# CITY OF OREGON CITY HISTORIC REVIEW BOARD AGENDA

Tuesday, March 31, 2026 at 7:00 PM

- a. HR-25-00017: Alterations to the R.S. Beattie House at 103 Jersey Ave

- a. Compatible Change: New Construction Review in Historic Districts- HRB Policy and OCMC 17.40 Code Review

*Existing wood siding sample showing 6.5-inch reveal and 1-inch channel*

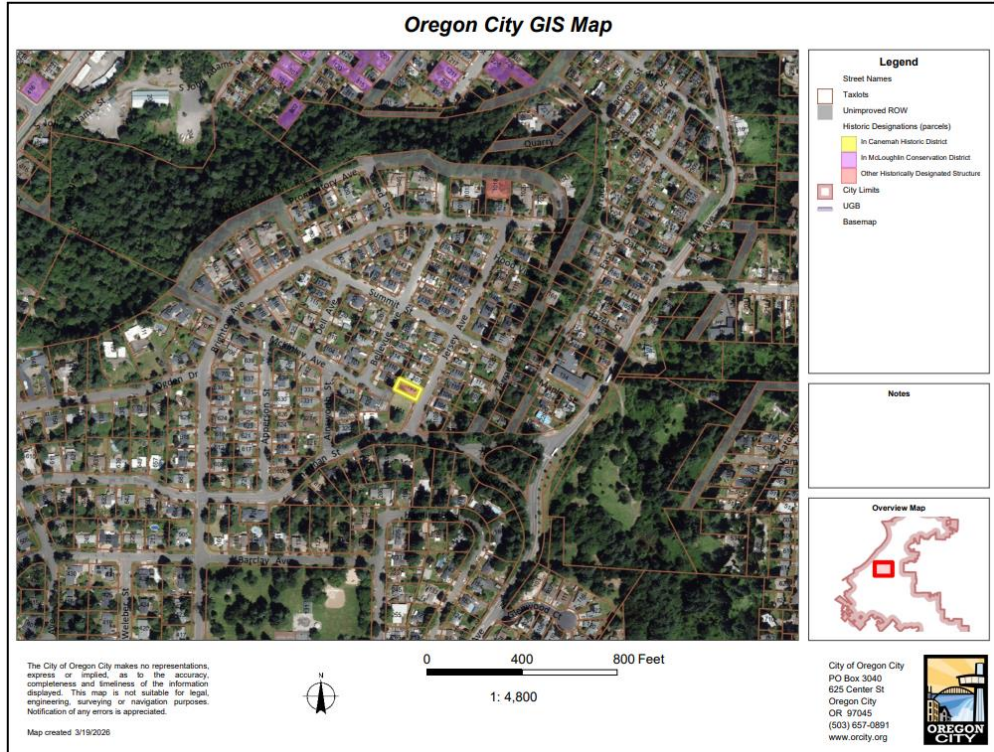
**Existing Siding Specifications:**  $\frac{3}{4}$ -inch thick (1/2 inch in the channel section) wooden shiplap siding with a 6.5-inch reveal and 1-inch channel height.

The applicant is proposing to replace the existing, deteriorating wood shiplap channel siding with fiber cement board of a similar thickness, reveal, and effect.

1. The applicant shall replace the existing wood siding with fiber cement board that is [redacted] in thickness with [redacted] reveal to adequately replicate the existing wood siding.

Sample A: Hardie Artisan V-Groove Fiber Cement Siding

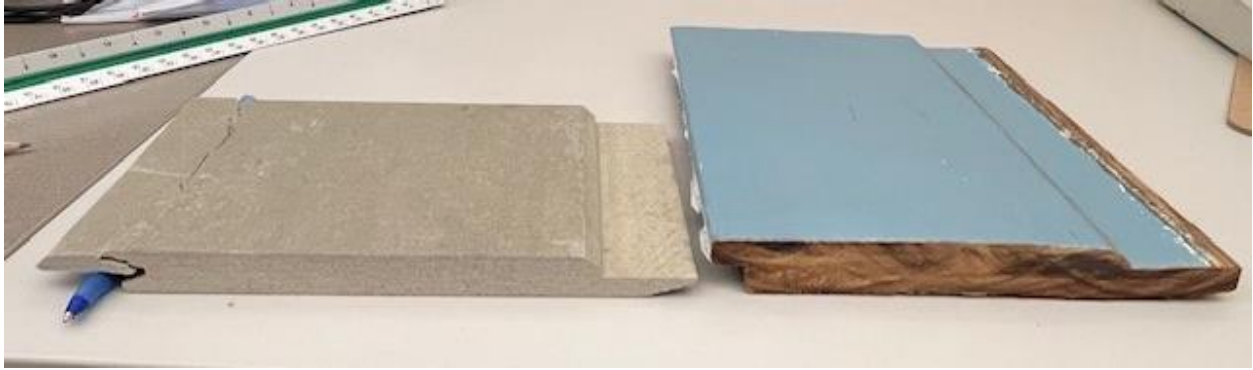
5/8-inch thick, 8-inch reveal, lateral V-groove

*Sample A Plan View showing 8-inch reveal and V-groove on the left*

**Finding:** Staff seeks direction from the Historic Review Board on the samples provided by the applicant and their suitability to replace the existing wood siding.

Sample B: Hardie Artisan Square Channel Fiber Cement Siding  
5/8-inch thick, 9-inch reveal, 1-inch lateral channel

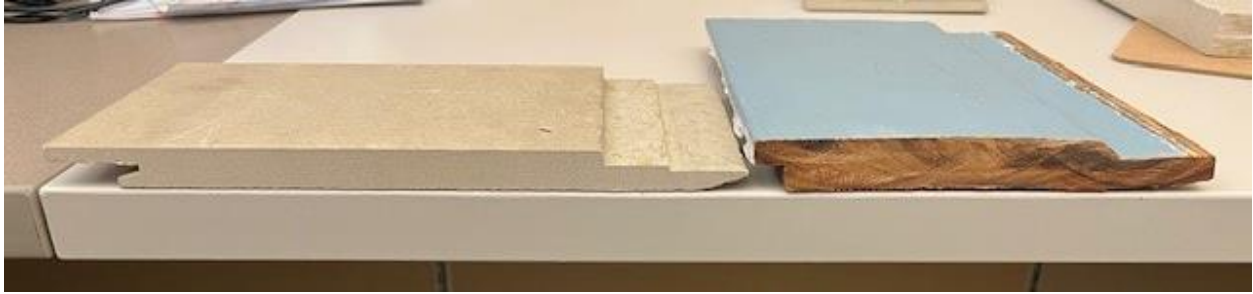
*Sample B Plan View showing 9-inch reveal and 1-inch channel on the right*

*Sample B (L) vs Existing siding (R)*

Sample C: Fiber Cement Channel Siding (unknown origin)  
5/8-inch thick, 10-inch reveal, 1-inch lateral channel

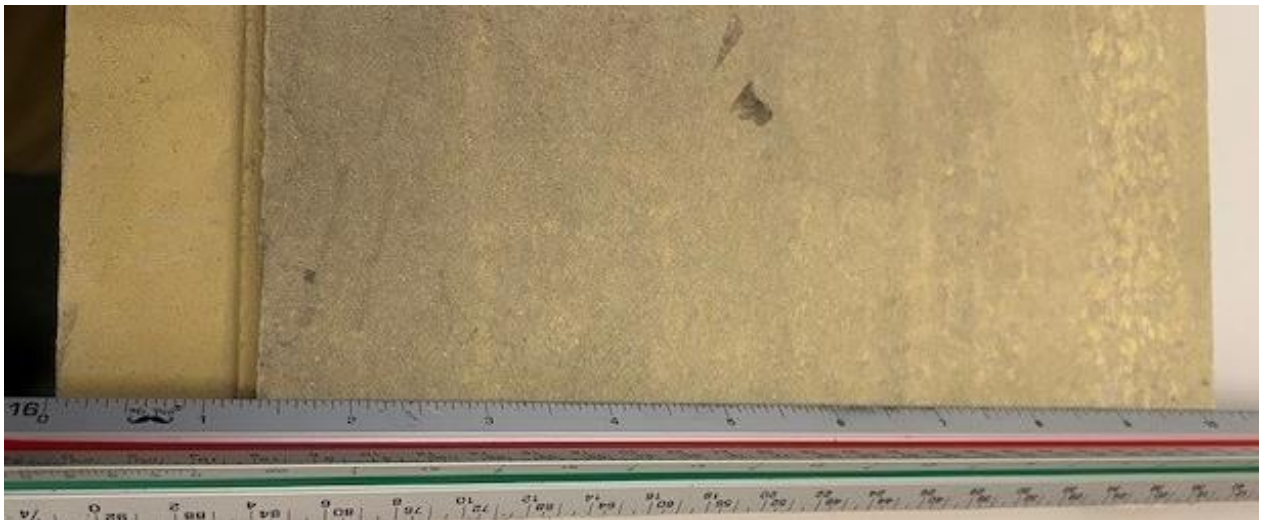
*Sample C Plan View showing 10-inch reveal and 1-inch channel on the left*

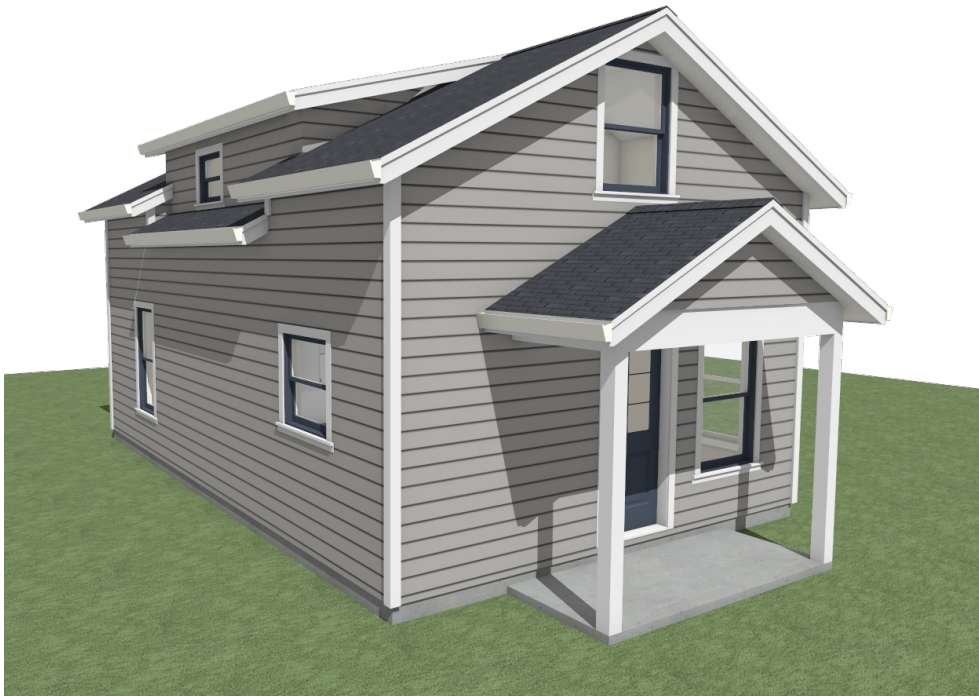
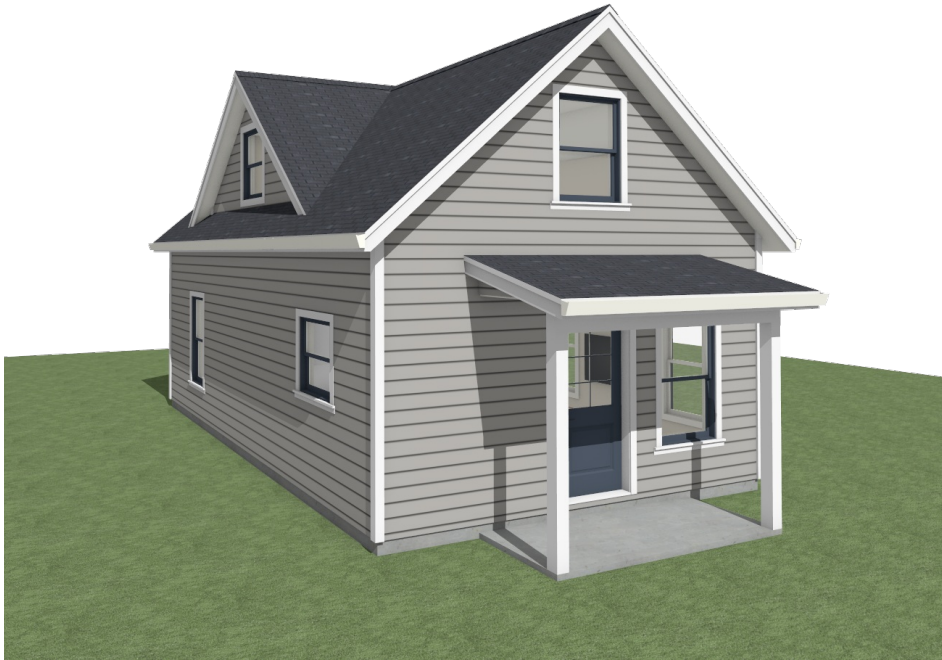
TO MAINTAIN A 14 FT MAXIMUM TO THE MIDPOINT OF THE ROOF, BOTH DORMER AND THE MAIN ROOF RIDGE HEIGHT NEEDS TO BE REDUCED AS THE MAIN ROOF SLOPE DECREASES. THAT SIGNIFICANTLY CHANGES THE INTERIOR CEILING FROM FLAT TO SLOPED IN MOST OF THE DORMER AREA.
